MEMORANDUM FOR RECORD

SUBJECT: Addendum to *Siting Analysis of Chinook Hangar and Outdoor Parking at Fort Wainwright, Alaska (January 15, 2009)*

1. Purpose. To address alternative siting location submitted by National Park Service and clarify U.S. Army Garrison Fort Wainwright's preferred siting location.

NPS Hangar Reuse and Siting Recommendation

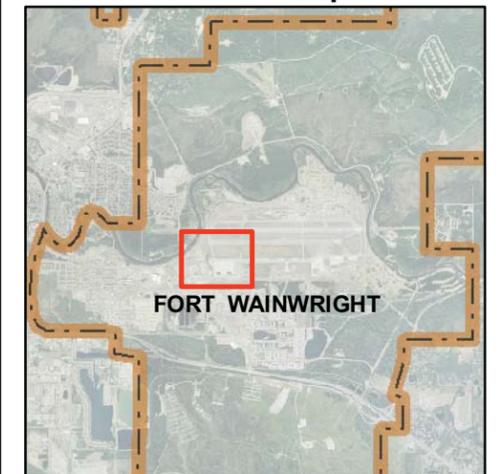
1. Incorporate Hangars 2 & 3 into Army's aviation storage needs for this project.
2. Incorporation of Hangars 2 & 3 into plans should reduce square footage needs of new hangars as discussed on page 5 of draft EIS.
3. Move Chinook Hangar west to southwest corner of airfield as illustrated at left.
4. It is assumed that with part of U.S. Army Alaska's aviation warm storage needs being met by Hangars 2 & 3 that one or both of the new hangars will be reduced in size, allowing the Chinook Hanger to fit in Site G as proposed.

b. U.S. Army Garrison Fort Wainwright Directorate of Public Works Master Planning Division (Master Planning) reviewed the NPS's alternate siting recommendation for siting feasibility. (See Attachment 2). Master Planning repositioned the new Chinook helicopter hangar within the NPS's suggested area using the following prohibitions: structures within the airfield clear zone; fixed and mobile objects on primary airfield surface; height and vertical slope of buildings within transitional surface; fixed and mobile objects within 150 foot clearance from taxiway centerline; and 82-foot standoff distance from roadway and parking to building. Even though the repositioned Chinook helicopter hangar meets the airfield safety guidelines, there are several other factors that prevent this option from being considered as a feasible siting location. The existence of a primary drainage slough and utilities corridor which cannot be relocated is a major limiting factor of this site. In addition, this alternate location limits the operational capability of the hangar as well as eliminates a needed "wind shield barrier" between the Chinook and Kiowa helicopters. Also, the movement of the new hangar further away from the water deluge building (which would be used for fire suppression activities) would increase the fire danger risk. Finally, relocation of the Chinook hanger would severely impact a prominent public viewing point of the Ladd Field National Historic Landmark, primarily Hangars 2 and 3 and their relation to Hangar 1 and the rest of the historic airfield. Based on this siting review, the NPS alternate hangar siting recommendation is not a reasonable alternative.

**LADD FIELD
(Site G Alternative)**

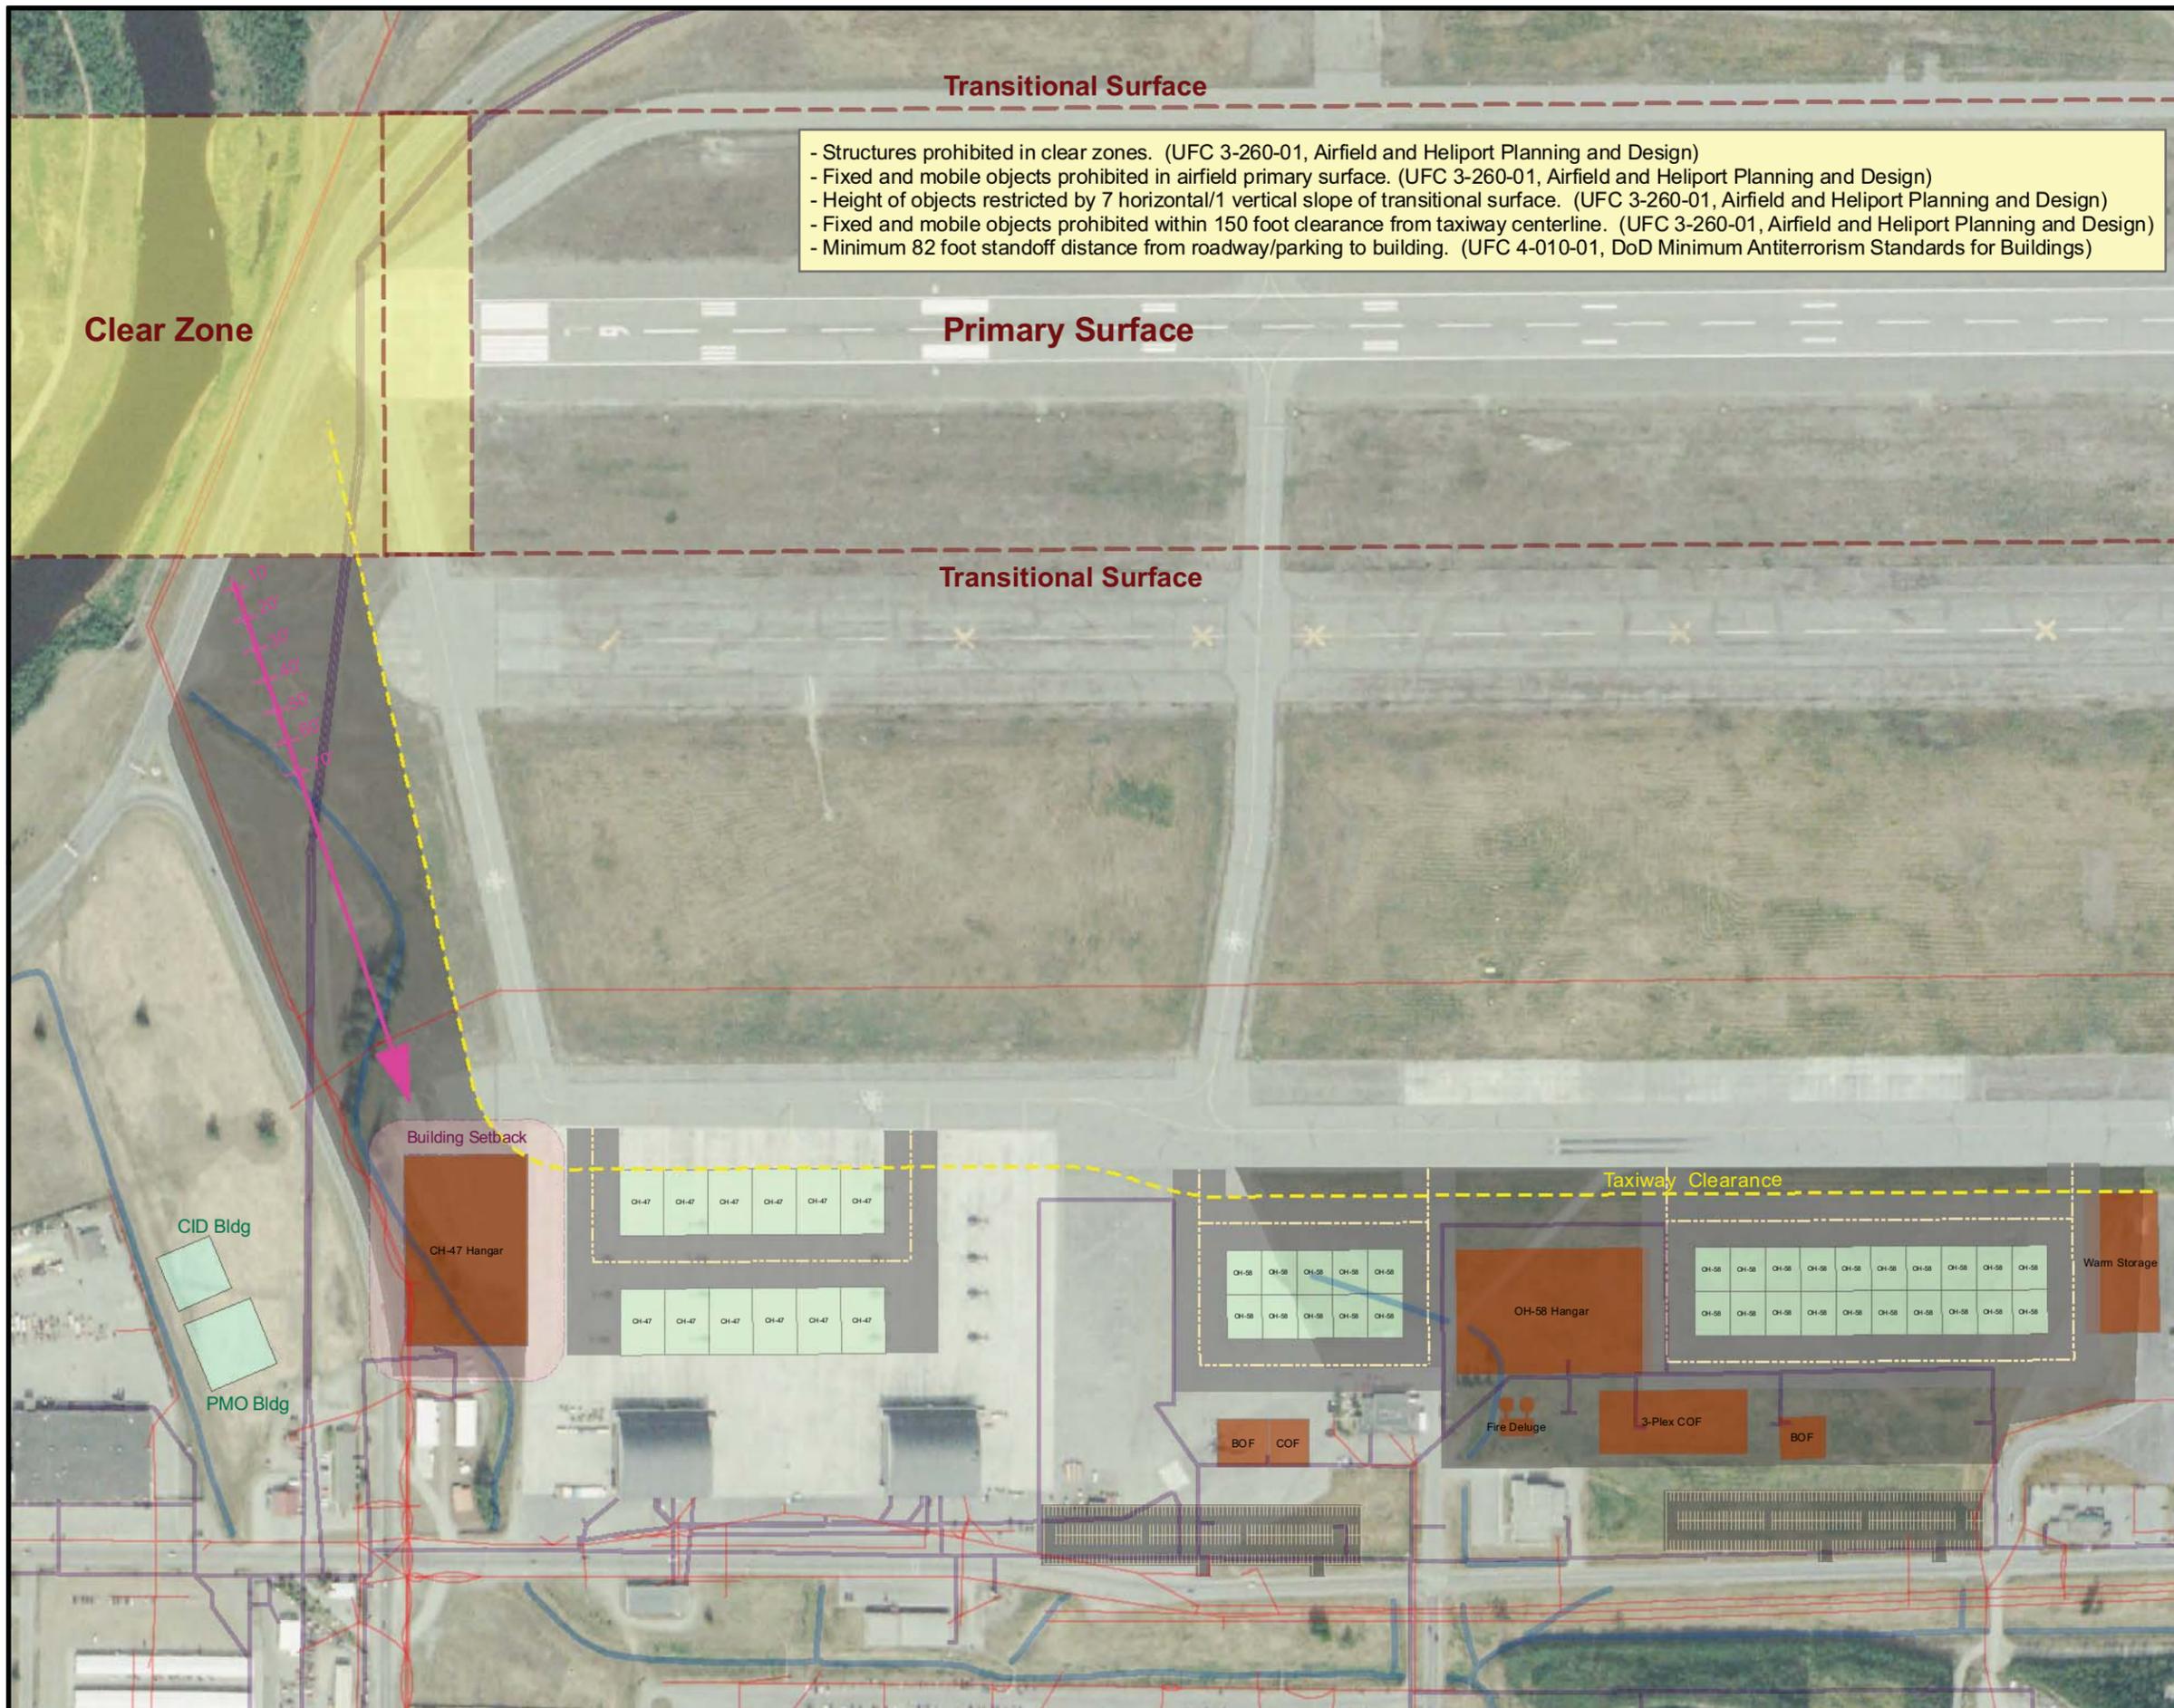
- Structures prohibited in clear zones. (UFC 3-260-01, Airfield and Heliport Planning and Design)
- Fixed and mobile objects prohibited in airfield primary surface. (UFC 3-260-01, Airfield and Heliport Planning and Design)
- Height of objects restricted by 7 horizontal/1 vertical slope of transitional surface. (UFC 3-260-01, Airfield and Heliport Planning and Design)
- Fixed and mobile objects prohibited within 150 foot clearance from taxiway centerline. (UFC 3-260-01, Airfield and Heliport Planning and Design)
- Minimum 82 foot standoff distance from roadway/parking to building. (UFC 4-010-01, DoD Minimum Antiterrorism Standards for Buildings)
